GULF STATES UTILITIES COMPANY

River Bend Station-Unit 1
Docket No. 50-458

Enclosed is the Gulf States Utilities Company (GSU) response to Safety Evaluation Report (SER) Confirmatory Item #19 - Hydrogen Control (SER Section 6.2.5, Page 6-32/33.) Attachment 1 contains the GSU endorsements for various Hydrogen Control Owners Group (HCOG) submittals. These letters should be utilized to provide background and reference material for SER Confirmatory Item #19. Attachment 2 contains a revision to the Request for Additional Information (RAI) on the Hydrogen Ignition System (HIS) transmitted to W. J. Cahill (GSU) by A. Schwencer (Nuclear Regulatory Commission - NRC) on December 2, 1983 and supercedes the original GSU response from J. E. Booker (GSU) to H. R. Denton (NRC) dated December 30, 1983 (GSU Letter No. RBG-16679).

REQUEST FOR ADDITIONAL INFORMATION FOR USE IN THE EVALUATION OF
THE HYDROGEN IGNITION SYSTEM FOR THE RIVER BEND STATION, UNIT 1
MARK III CONTAINMENT

E&DCR C-13,408

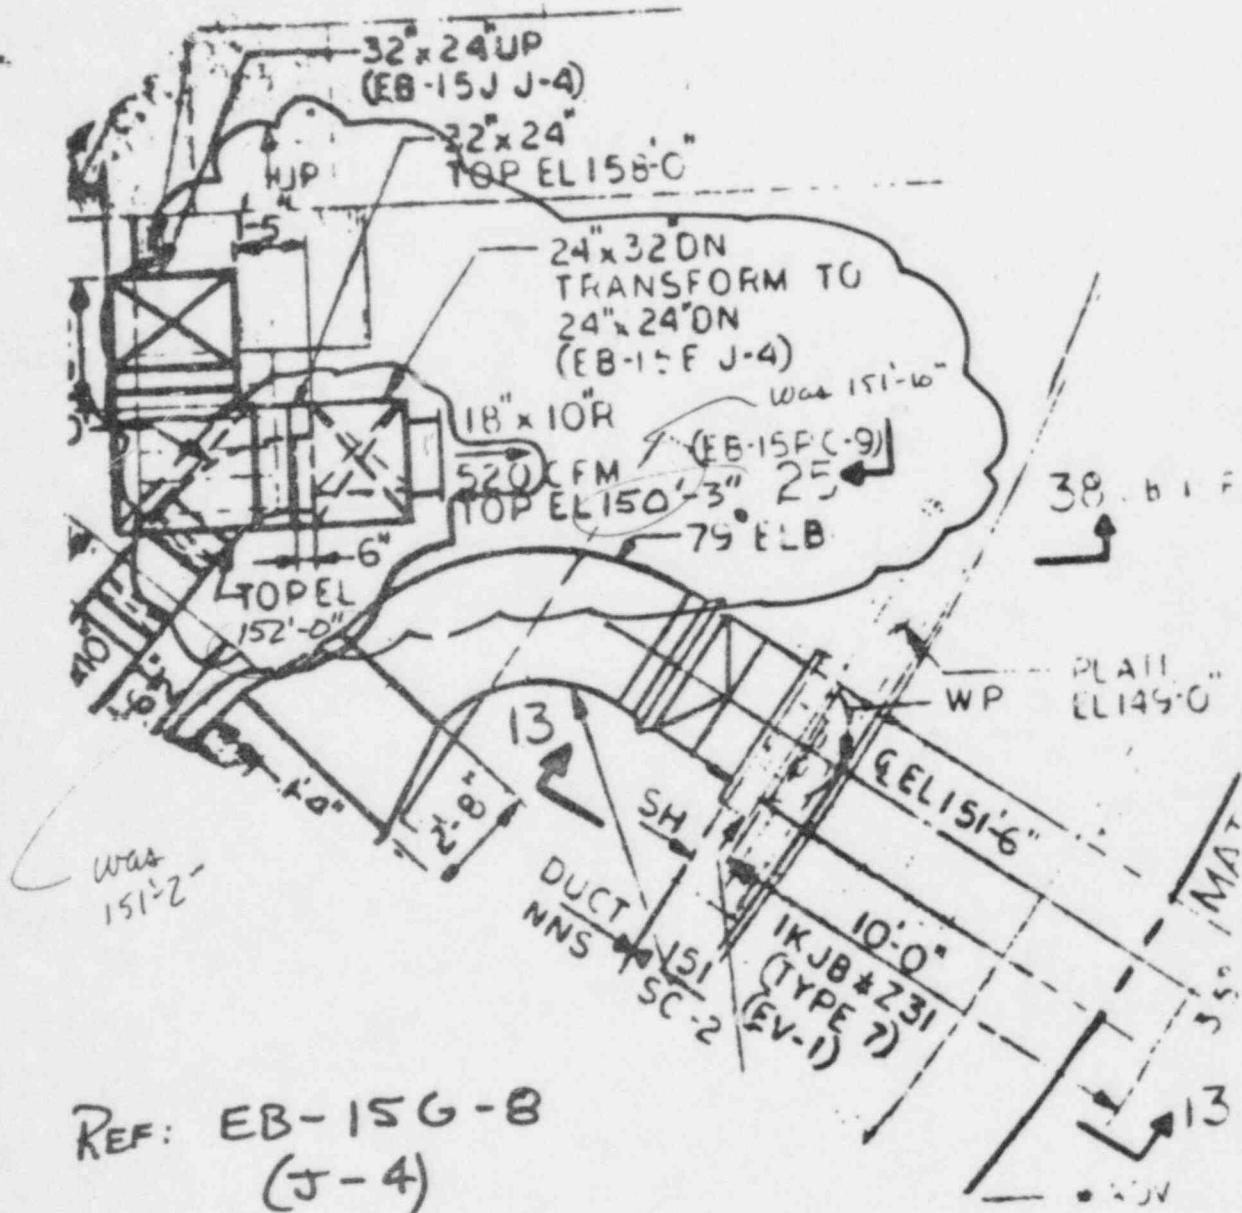
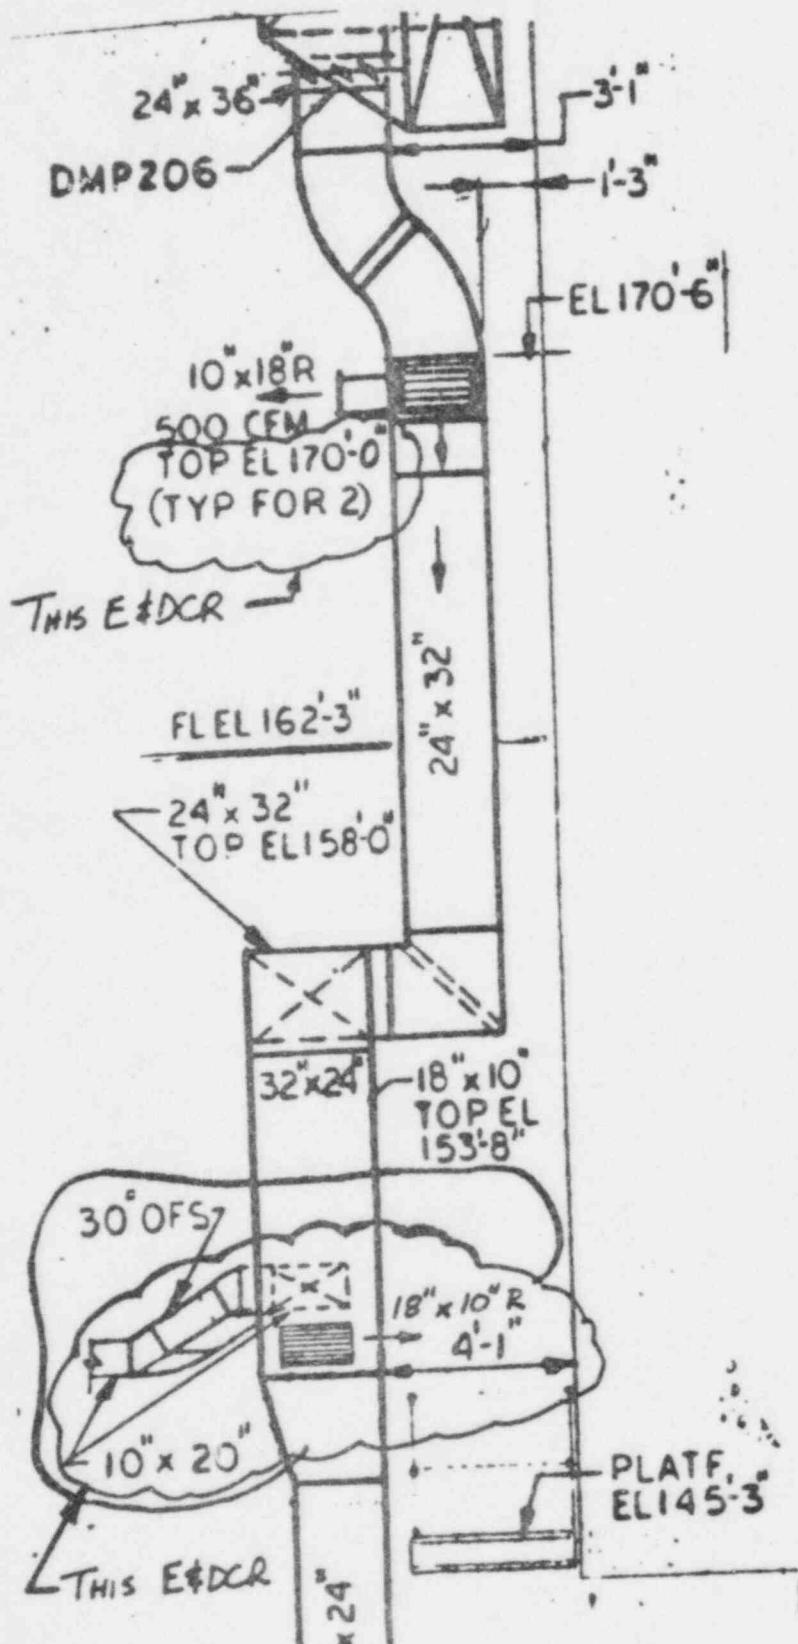
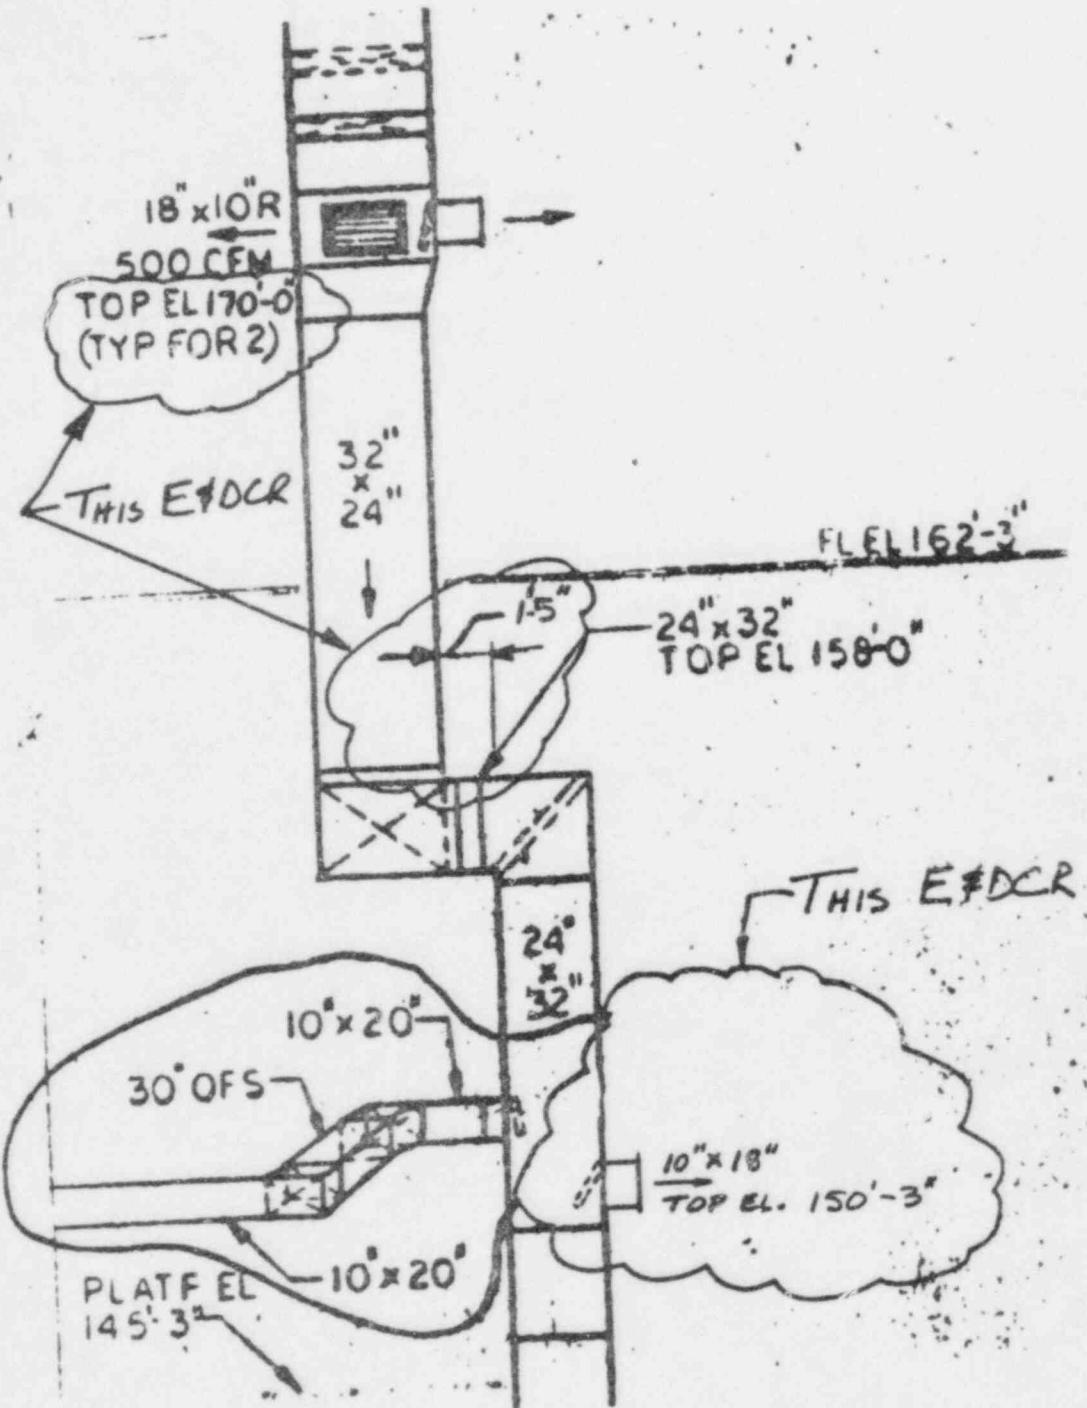
PROBLEM DESCRIPTION
 CONSTRUCTION REQUEST THAT THE VERTICLE SUPPLY DUCT FROM 1HVR*UC1A, 1B AND 1HVR*UC1C LOCATED AT AZIMUTH 30° IN THE REACTOR BLDG. SPANNING FROM EL. 138'-0" TO 182'-0" BE REVISED TO SHOW DULT TAP ELEVATION CHANGES DUE TO COORDINATING THE EXISTING DULT PIECES WITH THE SPECIFIED SUPPORT STEEL.

FOR SOLUTION REVISE THE DESIGN DWGS. AS FOLLOWS:

PAGE 2 OF 2
EDCR C-14044

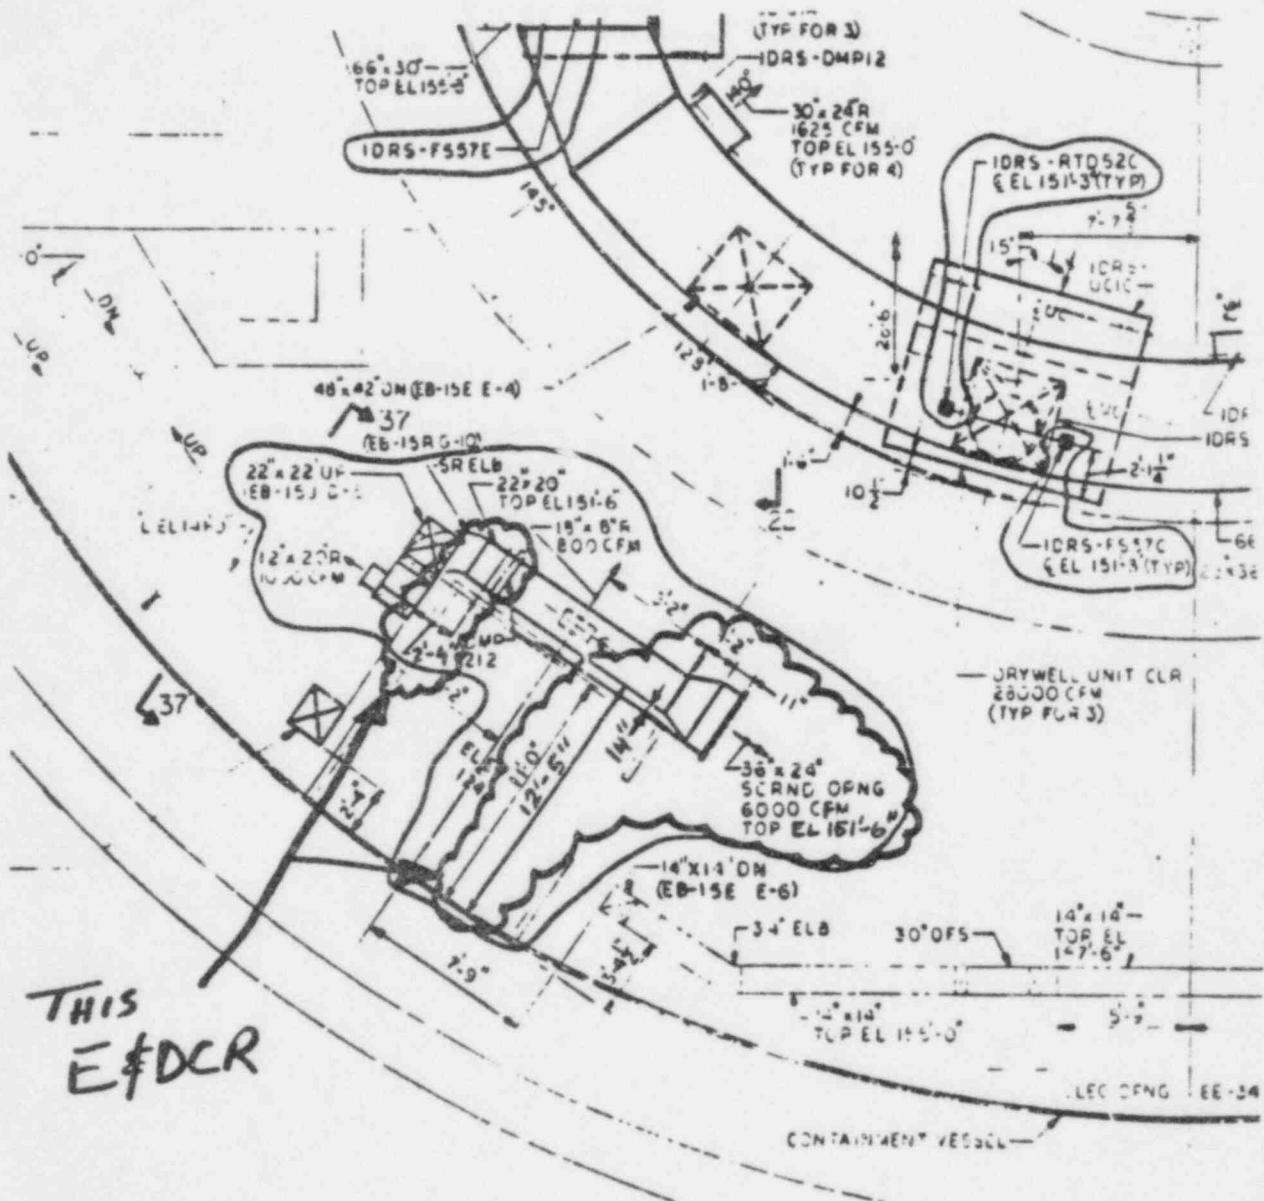
REVISE EB-156-8 AS ON PAGE 2 OF 2
OF THIS E&DCR.

E&DCR C-14,006 A

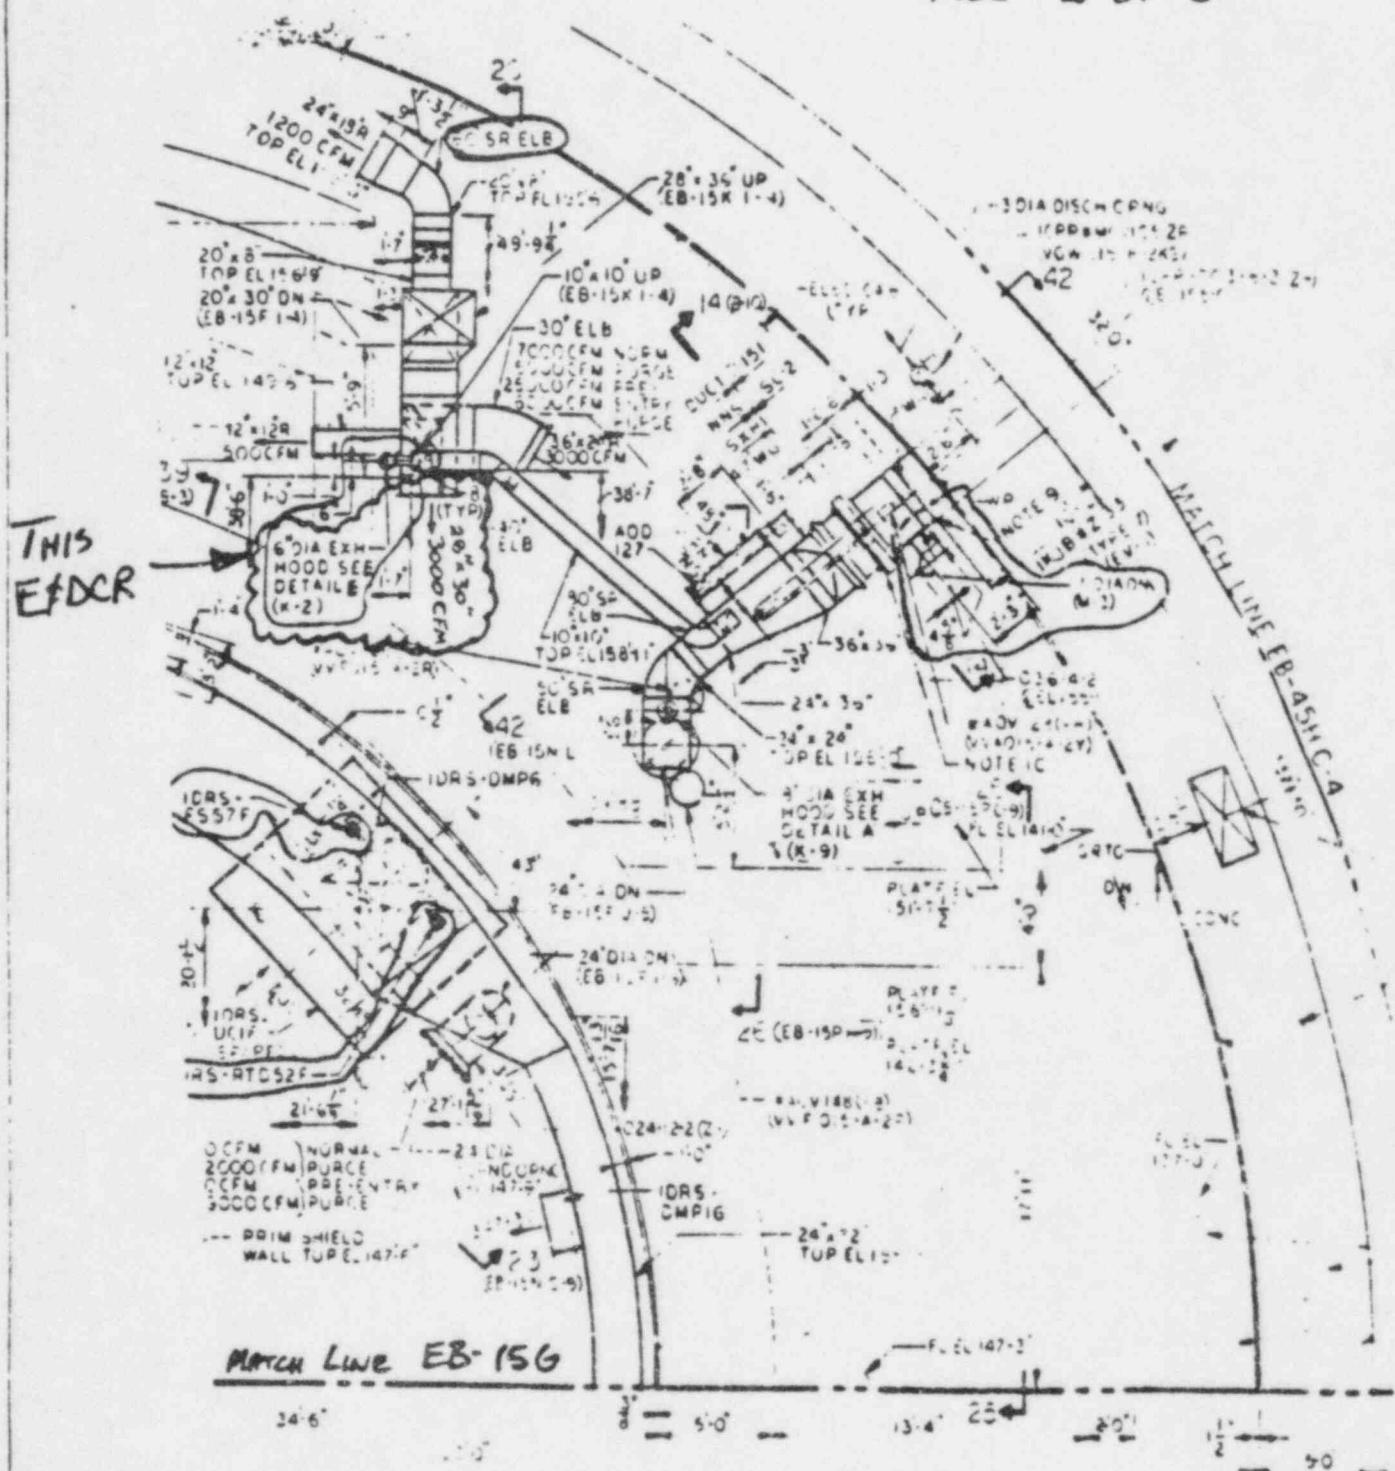
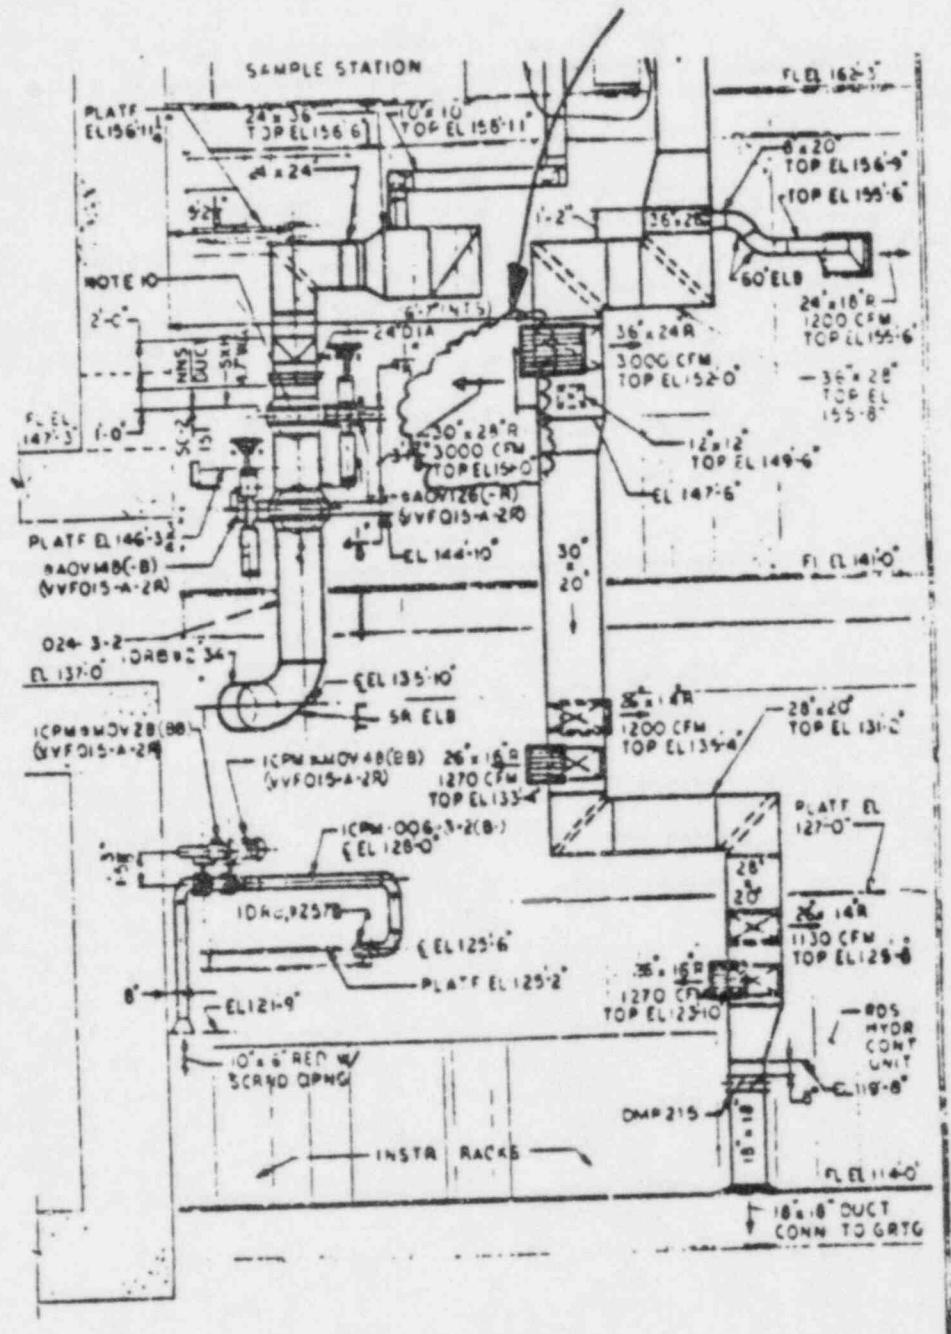
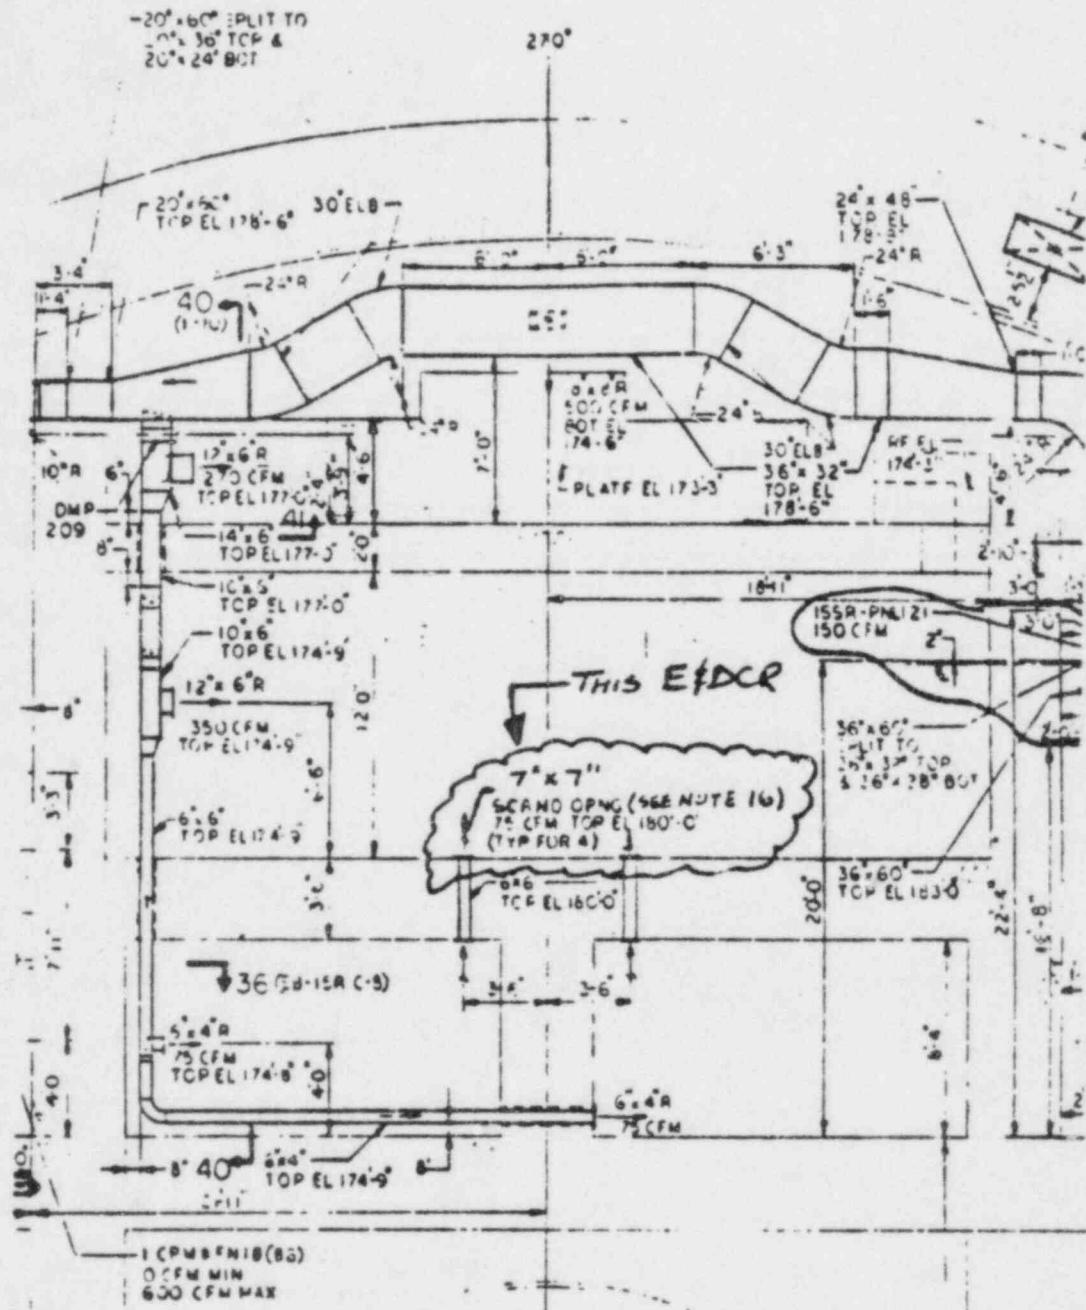
E&DR PAGE #	EB DWG. #	CHANGE
2 OF 5	EB-15H	REVISED DRYWELL DUCTWORK (PROBLEM 1) LOWERED DUCT 2" (PROBLEM 2)
3 OF 5	EB-15H	LOWERED DUCT 2" (PROBLEM 2) SECT. 53-53 & SECT. 16-16
4 OF 5	EB-15R	LOWERED DUCT (PROBLEM 2) SECT. 36-36
5 OF 5	EB-15J	DELETED RTD THERMOWELLS (PROBLEM 3)
